Change in the packaging of MELSOFT series products (manufactured in November 2017 and after)

iQ Works, GX Works3, GX Works2, MT Works2, GT Works3

FA-A-0245-A

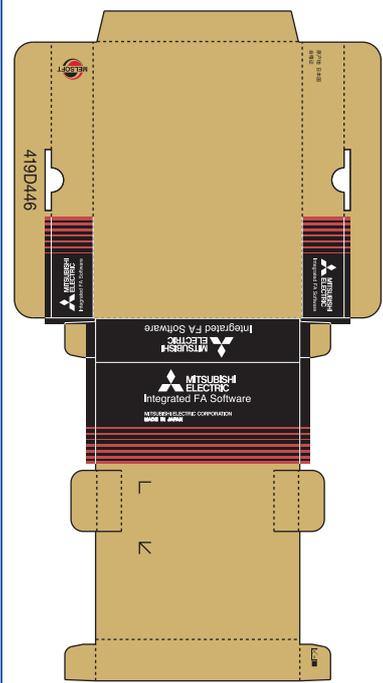
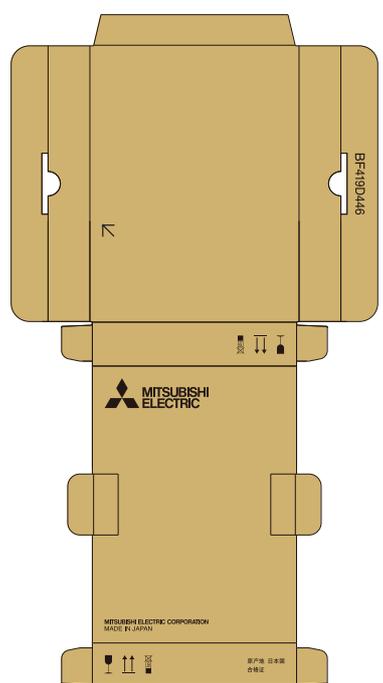
The corporate logo and the shipping marks on a packaging box are changed and printed in one-color.

Product name	Before change	After change
iQ Works GX Works3 GX Works2 MT Works2 GT Works3	<ul style="list-style-type: none"> • 3-color print • Shipping mark: 1 	<ul style="list-style-type: none"> • 1-color print • Shipping mark: 2 or more
